CEN/TC 267/WG 8 (MHD) « Maintenance of EN 13480 series »

MHD questions of 2025 on EN 13480 series

EN 13480 "Industrial piping and pipelines" Maintenance Group Question form

Figure B.2-1 – METHOD 2: Design reference temperature and impact test temperature, post weld heat treated (PWHT) condition, for $R_e \leq 265 \text{ N/mm}^2$ and $KV \geq 27 \text{ J}$. Dashed line only to be used for $KV = 40 \text{ J}$ and for thickness from 75 mm up to and including 110 mm

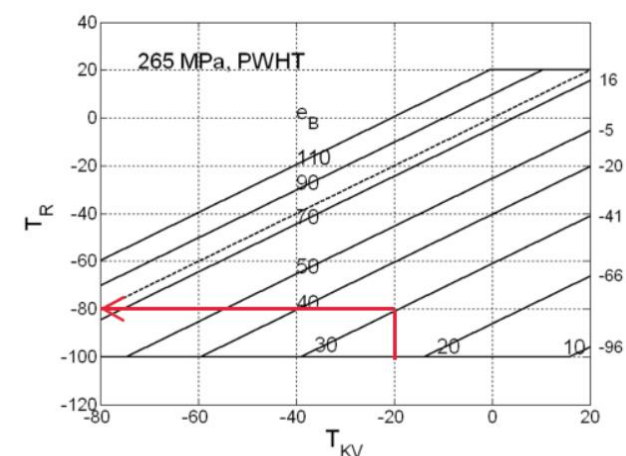
Q3. With above given condition 2, the figure B.2-1 is applicable. According to the figure B.2-1, we can read TR value of -80°C at above given condition2. If the impact test had been conducted at -20 °C and test result was more than 27J, does it mean that the pipe can be used down to design temperature of -80°C according to figure B.2-1?

This question is out of the scope of the Maintenance Working Group which shall not offer any consulting services

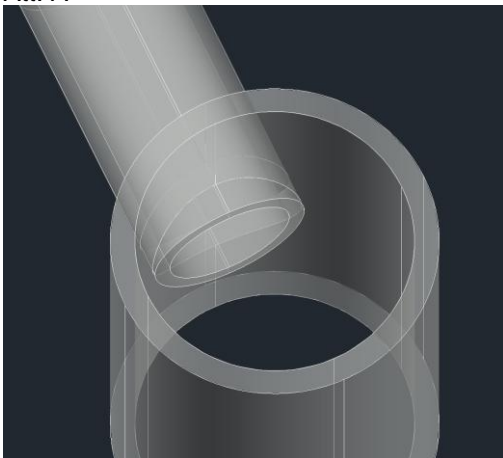
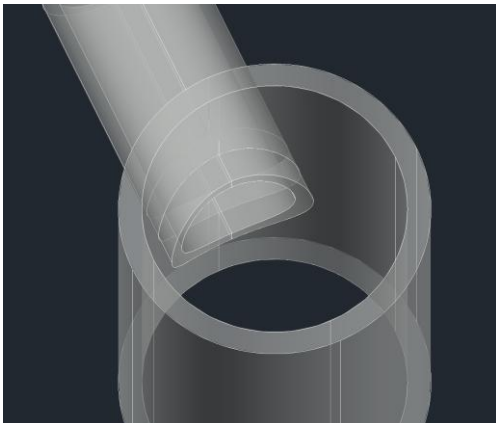
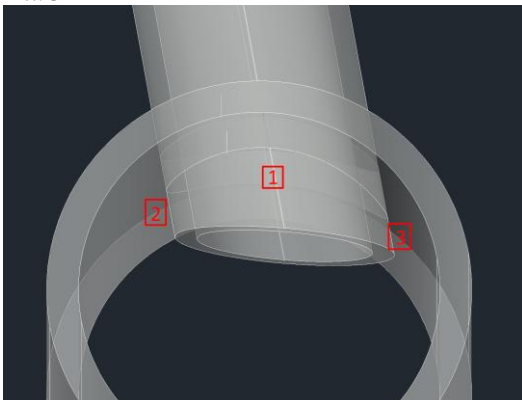
For set-through nozzles, in the longitudinal section for cylindrical and conical shells, a reinforcing length l'_b is indicated (i.e. 8.4.3-1), and it is measured from the inside wall to the protruding edge. It is unclear however if this specific protrusion is required only at the longitudinal section (= branch pipe may be cut square, see attachment A) or if it has to persist along the intersection, as in attachment B. Since there's no clear normative explanation it has caused disagreements between fitters, designers and NoBo. Especially for larger d_i/D_i ratios with a small l'_b , the branch pipe's protruding edge intersects the internal shell wall when cut square, which means the reinforcement is only very local.

The lack of clarity is further complicated for non-radial branches in cylindrical shells (8.4.3 C refers to calculating the lateral section) and for oblique branches in spherical shells and dished ends, which also require calculation of the lateral section. 8.4.3-4 and 8.4.3-5 imply that the calculation had to be performed at 3 different points, as shown in attachment C, despite 8.4.3-5 showing a tapered protruding branch pipe that comes flush to the shell with no further explanation or calculation.

This aspect is already covered in EN 13480-3:2024, subclause 8.4.3 "Reinforced openings with $d_i/D_i < 0,8$ " (see Figure 8.4.3-4).

Figure B.1 — Dimensional details of spools

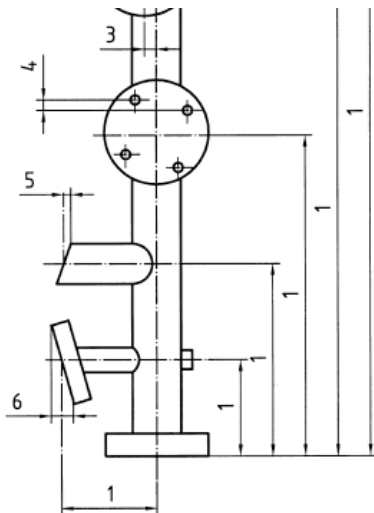
The flange in the schematic for piping spools has 4 bolt holes. For a flange with >4 bolt holes the standard does not state explicitly which bolt holes the rotational tolerance measurement applies.

The tolerance is strictest when applied to the bolt holes closest to the centreline. Please confirm if this is where the tolerance applies or if it applies to the top two bolt holes only?

Yes, the tolerance should be applied to the two bolt holes closest to the centreline.
The Annex B of EN 13480-4:2025 will be revised based on Figure 8.3.1-1. This modification needs to be carried out through the on-going Draft Amendment EN 13480-4:2024/prA1 under CEN Enquiry.

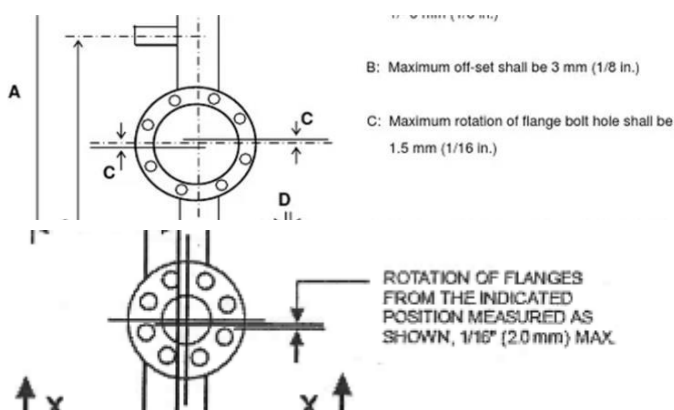
The tolerance should be applied to the two bolt holes closest to the centreline.

This aligns the EN13480-4 standard with ASME B31.3 and PFI ES-3 Standards where the tolerance is specified at the centreline.

The schematic will be updated to show a flange with >4 bolt holes so there is no ambiguity.
